AGENDA

Village of Chenequa Plan Commission
Monday, December 9, 2024 at 6:00 p.m.
31275 W. County Road K, Chenequa, WI 53029

STAFF REVIEW

Project Description: Proposed Single-family Dwelling and Landscape Plan

FRONT ELEVATION

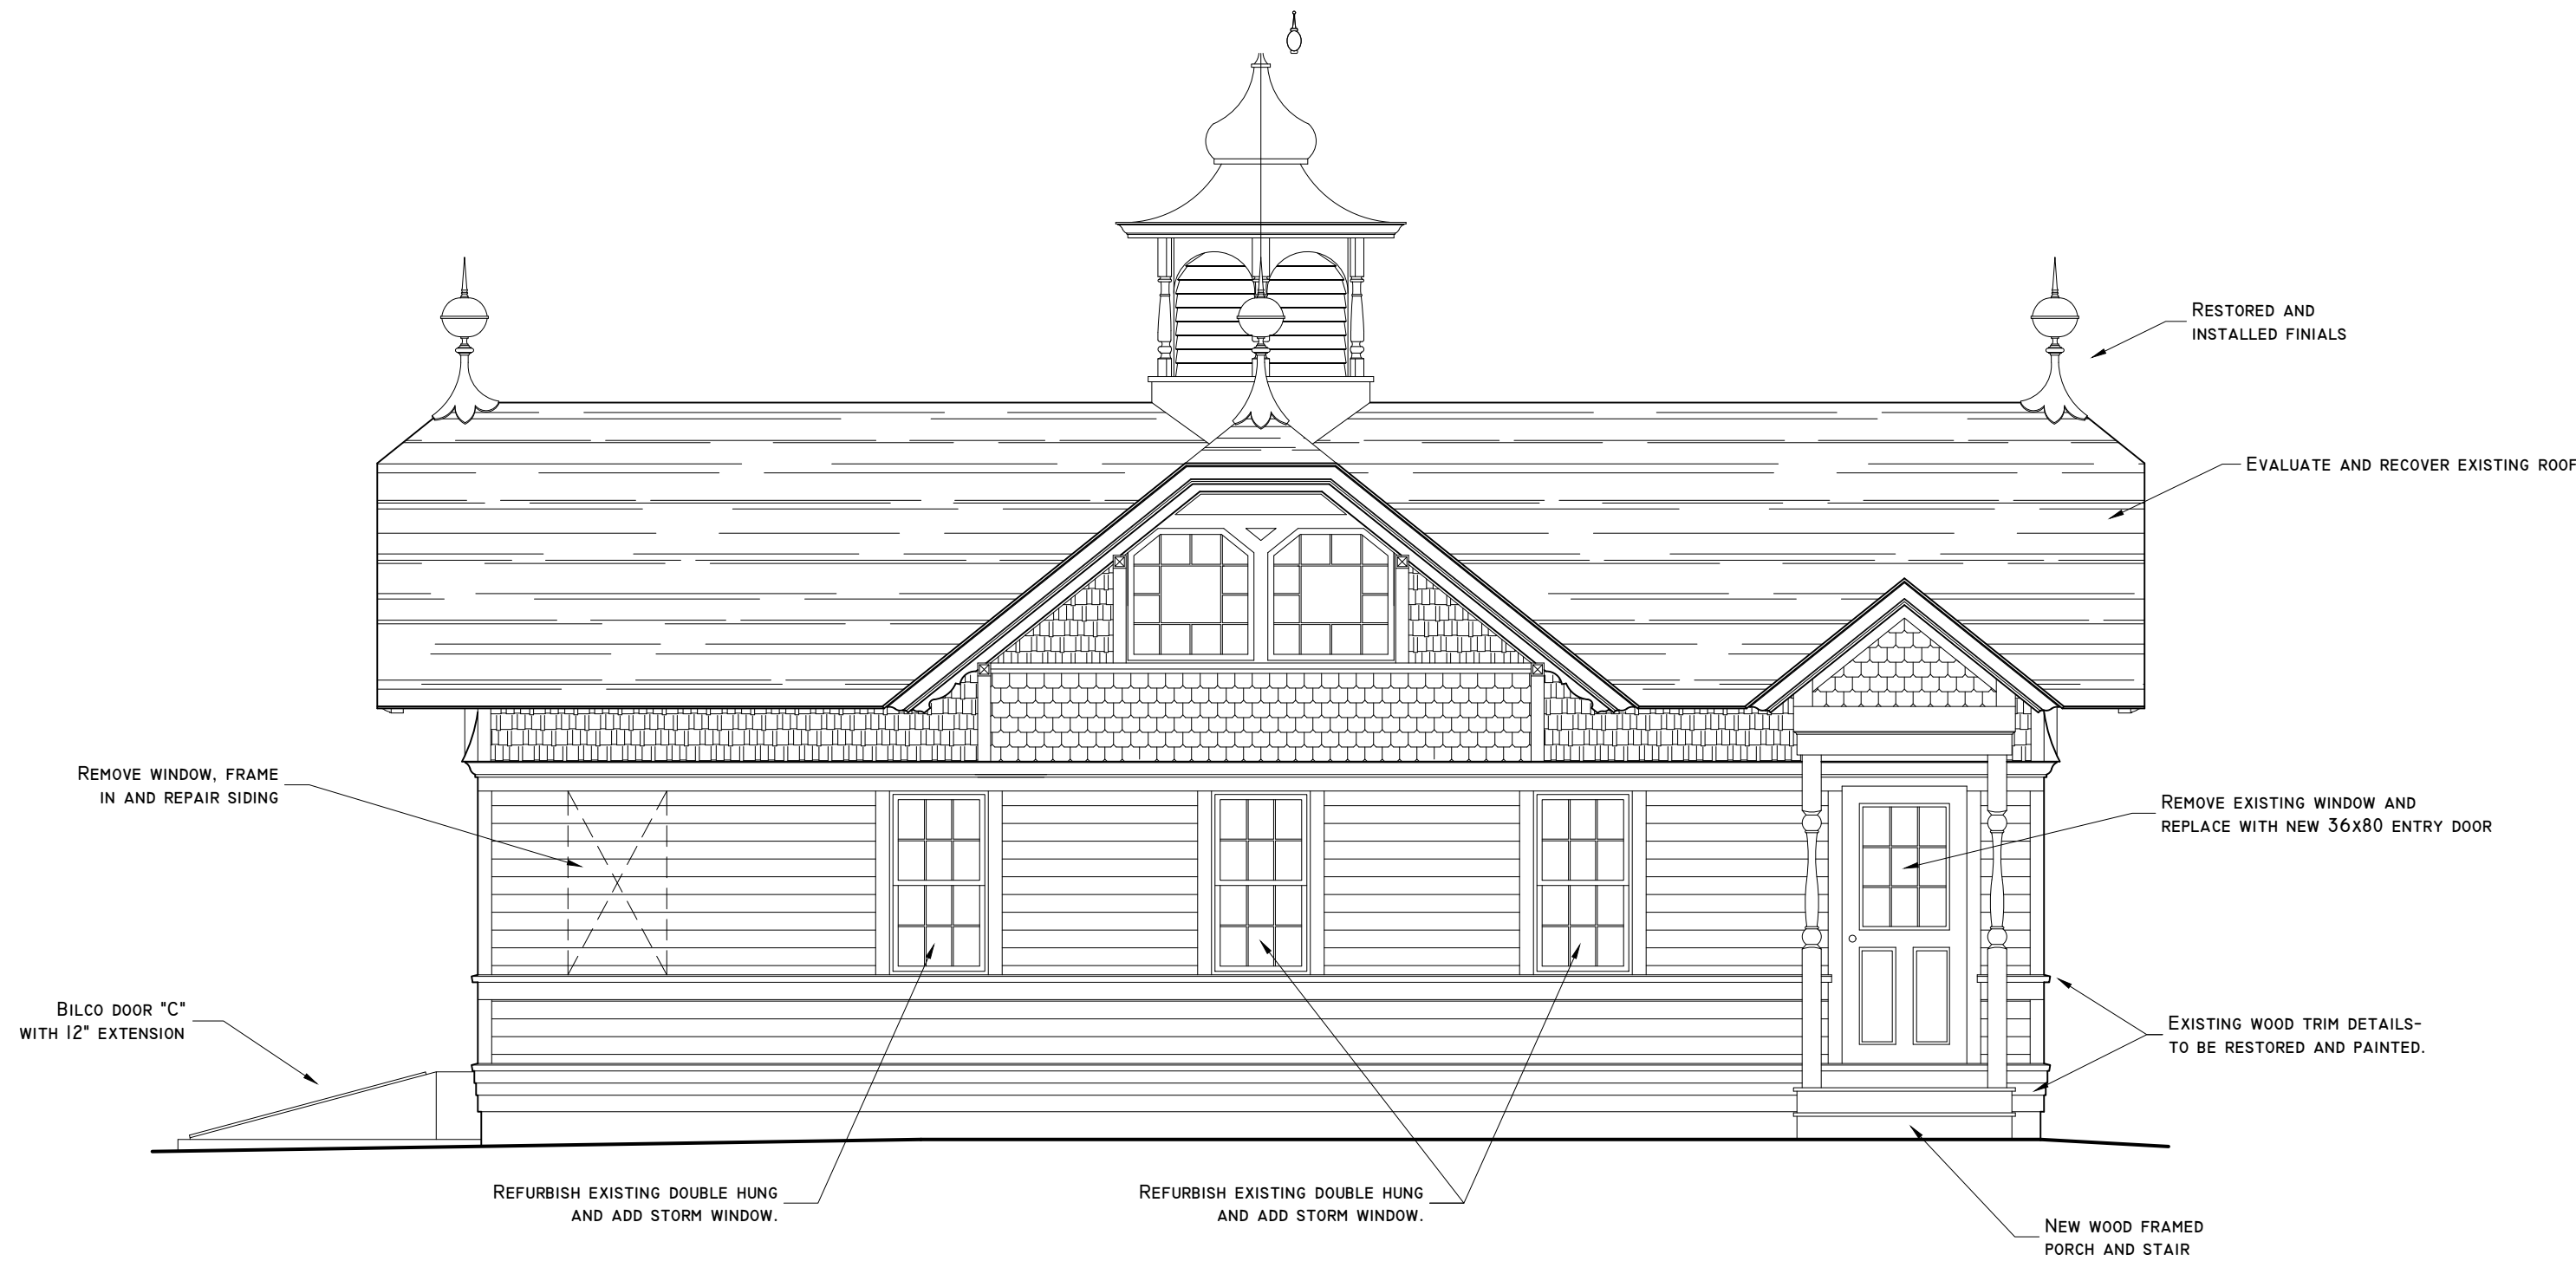
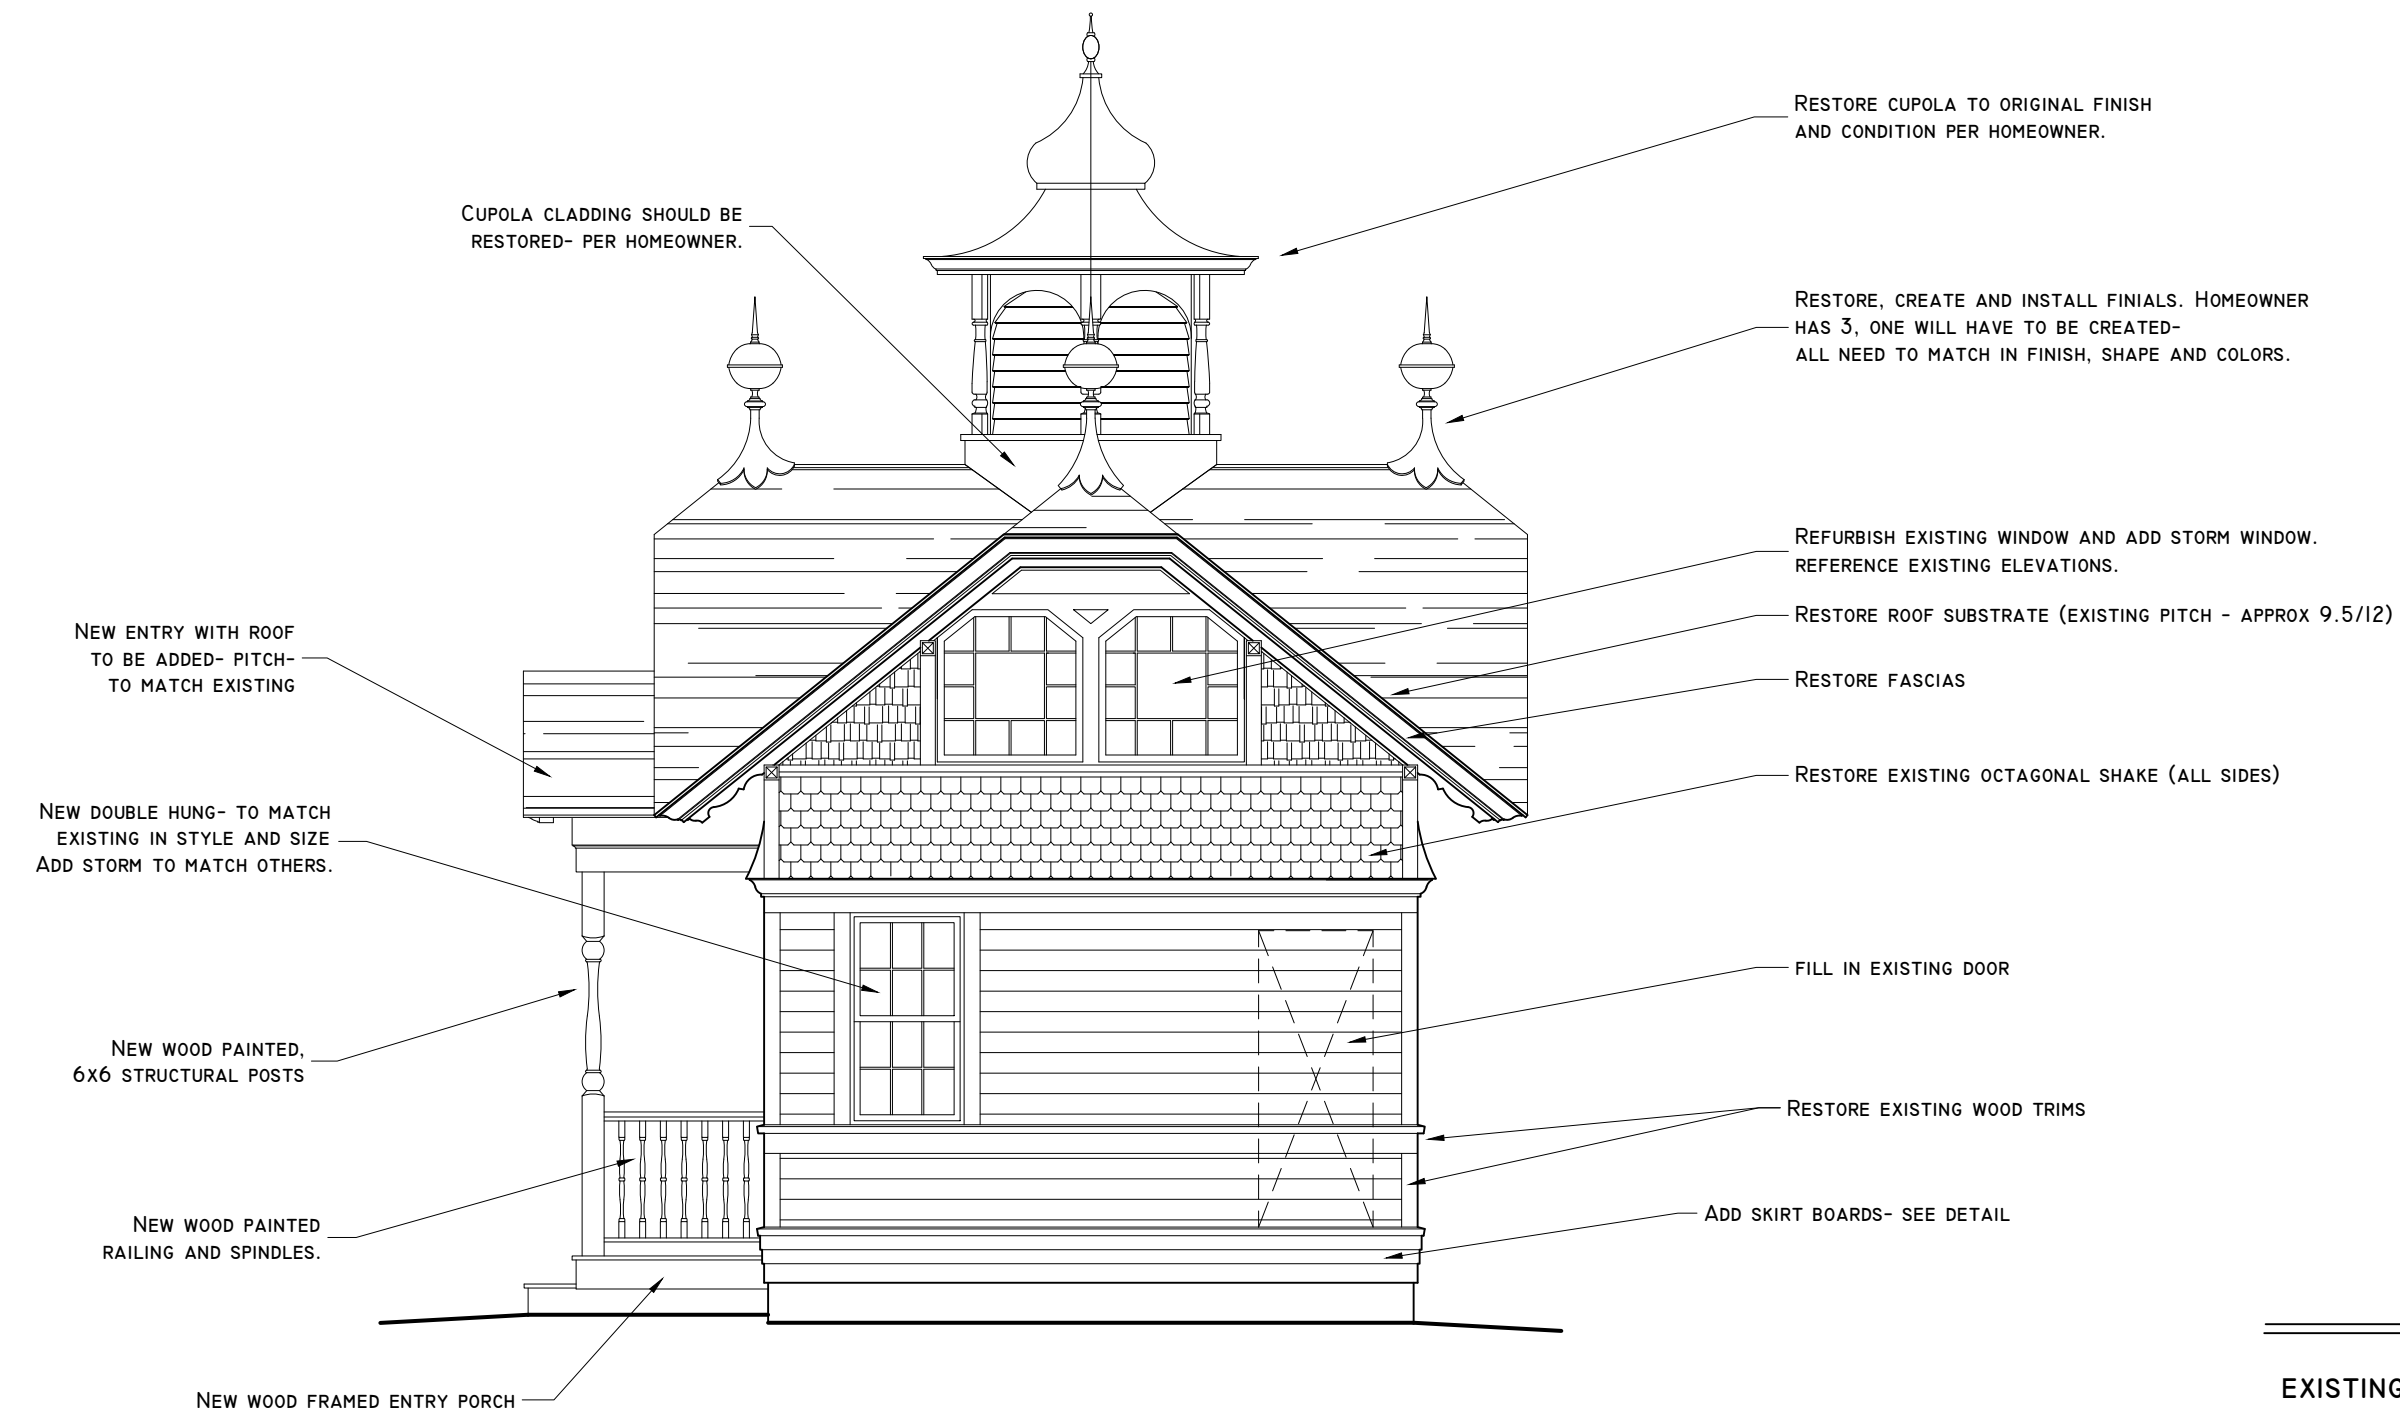
5. Existing and proposed elevations have been provided in your packet.
6. Exterior modifications include;
 - a. Repositioning doors and windows on the structure (as shown on plans)

- b. Installation of several new windows on the structure
 - c. Adding a small gable over the entryway (to match roof pitch)
 - d. Installation of bilco door to provide basement access

- e. Restoration of existing trim and siding
7. The existing color of this structure is white, this color is not proposed to change.
8. There is no exterior lighting proposed on this structure
